New Primary School in Murrumbateman

Road Safety Audit

Detailed Design Stage

JN22007_Report01 Rev02 - Hansen Yuncken MPS

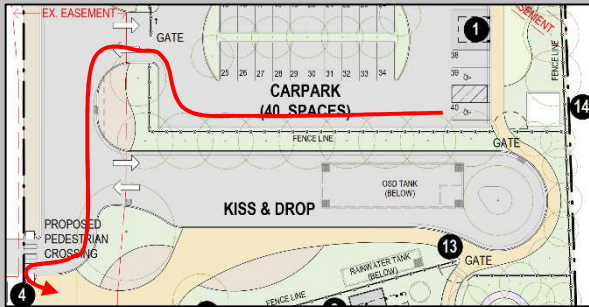
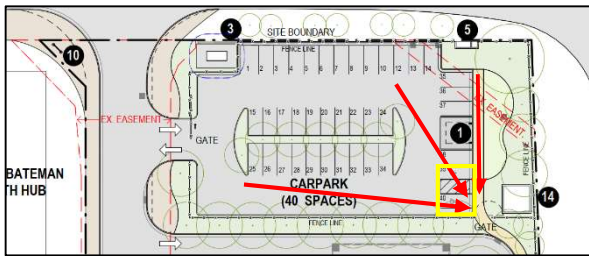
Item Location	Safety Hazard Finding	Frequency	Severity	Level Of Risk	Project Manager Response
1. Delineation Fairley Street	<p>The existing 'BB' centreline and intersection line marking on Fairley Street is damaged/faded.</p> <p>There is a risk that a motorist may not observe lane discipline and encroach into oncoming/turning traffic resulting in sideswipe or head-on collisions, particularly around conflict points such as intersections, turning vehicles and bus stops.</p> 	Improbable	Minor	Low	<p>Maintenance of BB Line on Fairley Street is the responsibility of Yass Valley Council.</p> <p>SINSW to forward RSA to Council for action.</p>

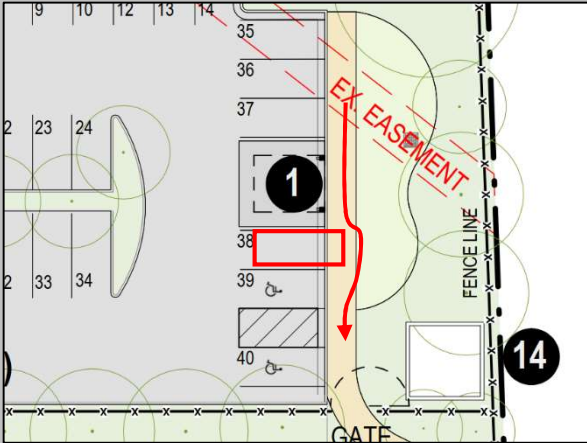
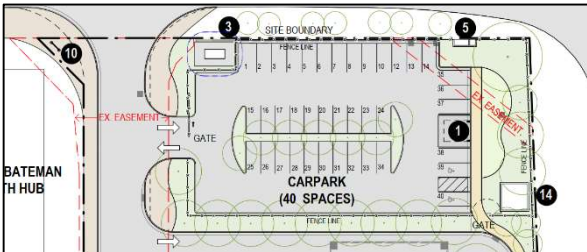
2. Sight Distance Fairley Street	<p>There is restricted sight distance between a northbound vehicle in Rose Street and a westbound vehicle in Fairley Street when the bus bay is being used.</p> <p>There is a risk that a motorist from Rose Street may enter Fairley Street in front on an oncoming vehicle resulting in side-impact or rear-end collisions.</p> 	Occasional	Minor	Medium	Sightline assessment to be prepared by Ason Group to determine modification required to the design of the bus bay.

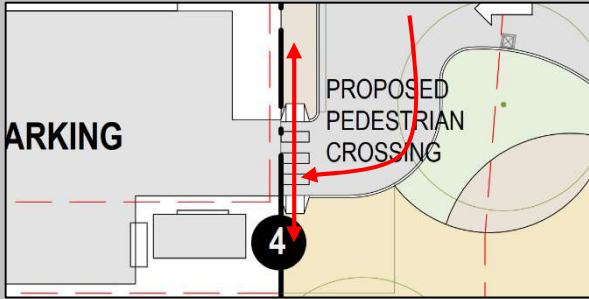
Item Location	Safety Hazard Finding	Frequency	Severity	Level Of Risk	Project Manager Response
3. Delineation Access Intersection	<p>There is white paint line marking on white concrete at the Access Intersection.</p> <p>There is a risk, particularly at night or during adverse weather, that a motorist may not sight the intersection configuration, hold line or lane discipline resulting in sideswipe, head-on or side impact collisions.</p> 	Probable	Minor	High	<p>The line marking issue is an existing condition that should be referred to Council being the local road authority to respond to.</p> <p>The matter can be resolved by repainting the line marking in yellow.</p>
